Daniel Welch,
Platting Officer

SD022-17 Chena Point Lake Subdivision

RP023-17 (Tanana Chiefs Medical Center)

**CHENA POINT LAKE
SUBDIVISION**

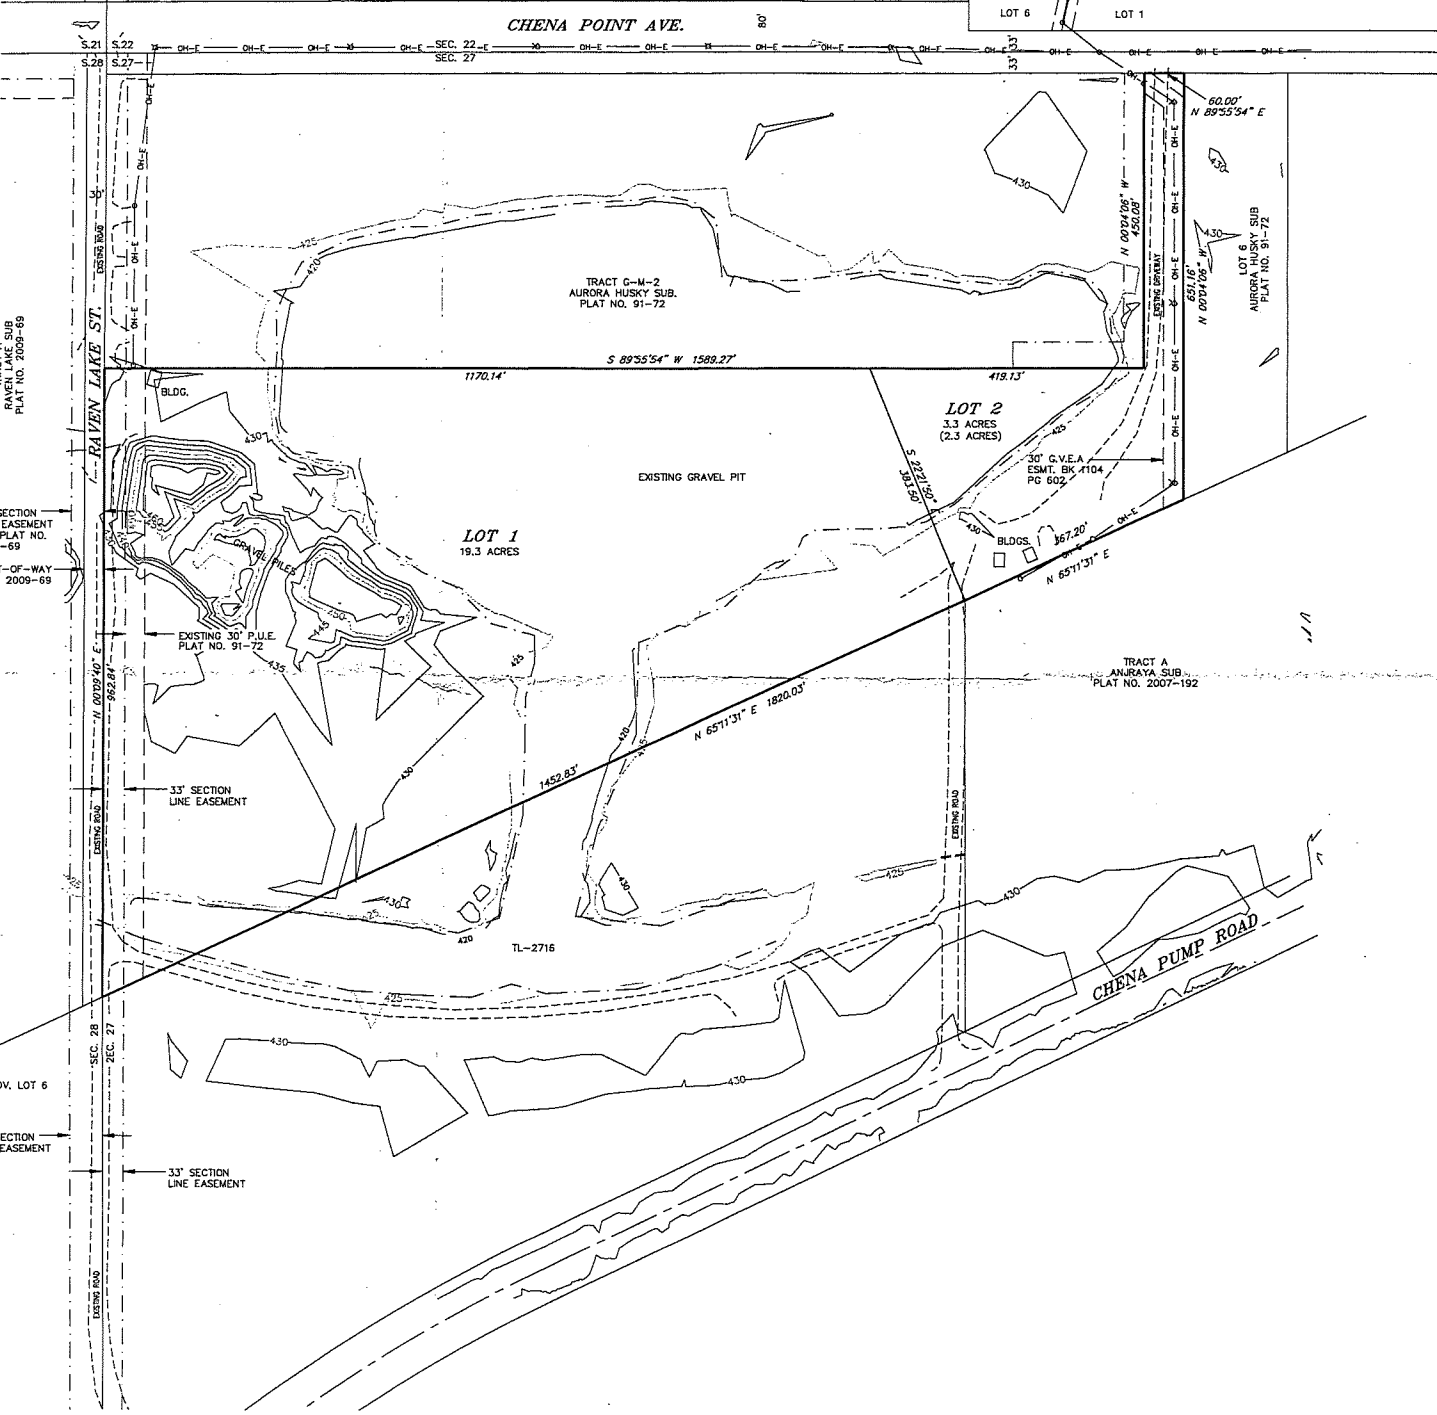
Public Works: (Ann Worhatch, Civil Engineer). “I reviewed the soils report and it is acceptable. I think it would be useful to add a dashed 100’ line from the water’s edge, as we discussed in the meeting today to delineate where it is okay to install a septic system on lot 2.”

- Plat Note 7 classifies this area as Flood Zone A. This area is Flood Zone AE. Please have them correct that on the preliminary plat.
- The final plat is required to show an existing or new benchmark as required per (FNSB 17.52.040 (D) (18) (a)):
 - Platting board shall require that benchmarks be placed within the subdivision as primary monuments and be stamped and noted on the plat with the North American Vertical Datum of 1988 (NAVD88) elevation determined to National Geodetic Survey third order vertical standards. The monumentation shall be placed so that no lot within Flood Zone A or AE is more than 1,000 feet from a benchmark.”

GVEA: “Golden Valley Electric Association, Inc. has no objection to approval of the above preliminary plat, as submitted on March 16, 2017, by Stutzmann Engineering Assoc., Inc. However, the PUE on the plat is misleading; as of 2016 that PUE was not useable due to the gravel pile. GVEA requests review of the final plat prior to approval.”

- 1) Add a Street Name "Chena Point"

2) Maybe in Note 1 instead of "guy" say "guy wire"?

3) On the Chena Point road itself in top center-there are numbers 80' and 33'-I can't figure what they mean, may be dimension them and add description in notes?"

The property does not contain wetlands but does fall within Flood Zone AE. The required note that the property is located within Flood Zone AE is incorrectly depicted on the preliminary plat because it states the property is within Flood Zone A (Note 7). The preliminary plat defines the BFE for each a lot as well as shows the expected drainage route via contours, as required by both Title 17 and Title 15. A benchmark will need to be placed and depicted on the final plat so that all proposed lots within Flood Zone AE are no more than 1,000 feet from a benchmark. This will be a condition for approval.

1. GVEA, IGU shall be a maximum of 30 calendar days as an opportunity to review and comment on the final plat.
2. ACS, DOT and Chena Goldstream Fire Service Area shall have 10 business days to review and comment on the final plat.
3. All easements of record shall be depicted and appropriately labeled on the final plat.
4. The bench mark requirements of 17.52.040(D)(18)(a) shall be depicted on the final plat.
5. All flood-related notes shall use the appropriate Flood Zone determination for the property of "Flood Zone AE."
